Montana Department of Transportation  
PO Box 201001  
Helena, MT 59620-1001

## Memorandum

Subject: Back Slope Rounding

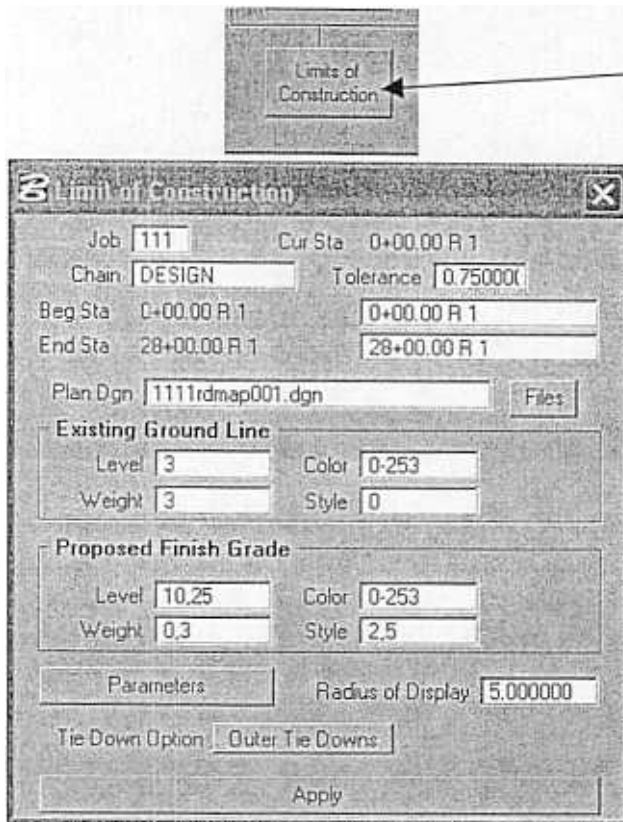
As the result of discussions with the District Construction Engineers we have determined that back slope rounding will be eliminated. The back slope rounding is not always constructed and is rarely constructed as currently shown in the plans. This results in a disparity between the actual and planned excavation quantities.

The District Construction Engineers indicated that if the construction limits are based on the catch point, there might not be sufficient right-of-way at the top of cuts for the placement of utilities or the construction of furrow ditches. Therefore, a simplified rounding detail has been developed. This will result in a construction limit that is 2 meters beyond the back slope catch point regardless of the back slope (see attached detail).

The attached simplified rounding detail will also need to be added to the note sheet in the plans and the note indicating that back slope rounding should be done in accordance with the Detailed Drawings should be eliminated.

The following note will replace the current note in the plans

"Note: Back slope rounding is not measured for payment. Include the cost of back slope rounding in the unit price bid for Unclassified Excavation."
